WRS8 – Reworking Screw Connection for Transmission Control Unit (Workshop Campaign)

Vehicle Type: **911 GT3 (992) / 911 GT3 Touring (992)**

Concerns: **Transmission control unit**

Installation position of screw connection for transmission control unit

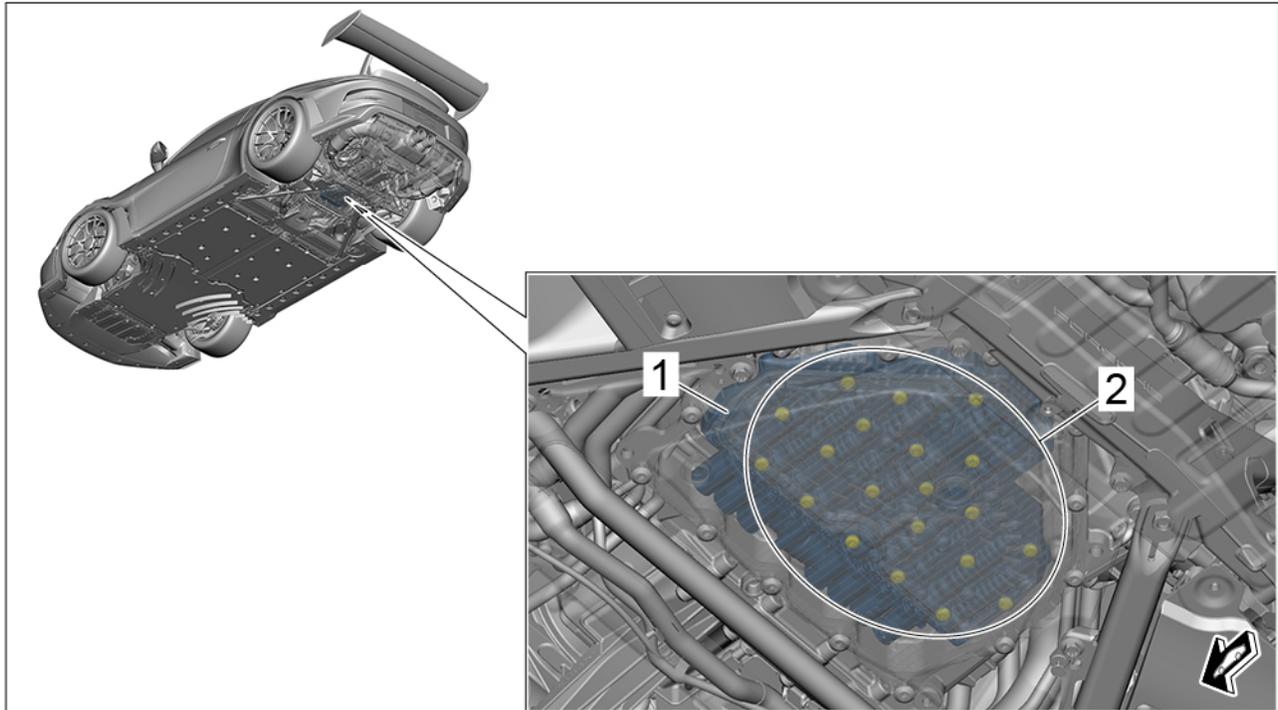
Cause: **Due to an incorrect specification in the Workshop Manual, it is possible that the screw connections on the transmission control unit installed as part of the WPJ7 campaign do not meet the intended specifications in the affected vehicles.**

Action: Replace the screw connection for the transmission control unit.

- 1** – Transmission control unit
- 2** – Screw connection for transmission control unit (**replacing**)

Screw connection for transmission control unit

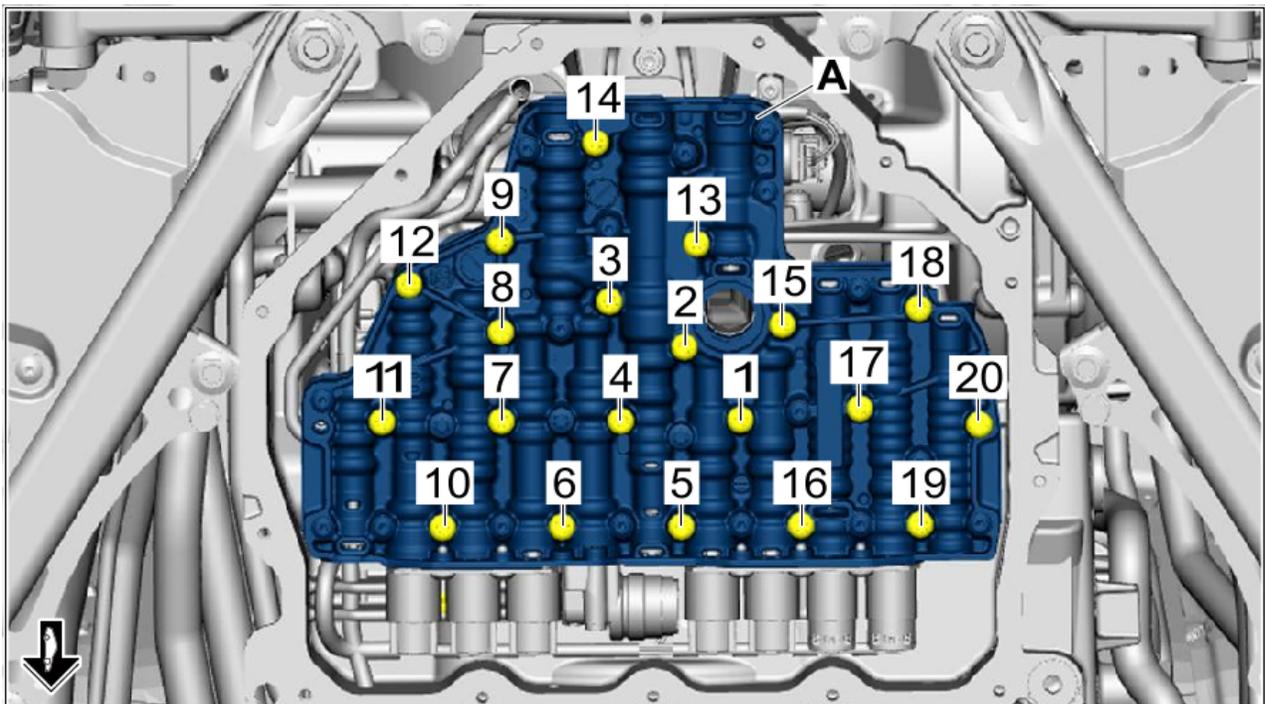
- 1 **Loosen** screws ⇒ *Screw connection for transmission control unit -1 to 20-* and replace them with **new** ones, one after the other.

- 2 Insert **new** screws manually **9768 - and tighten in sequence using an** electronic torque wrench ⇒ *Screw connection for transmission control unit -1 to 20-* (using the “Medium” tightening setting).

Initial tightening + yield strength 2.4 Nm
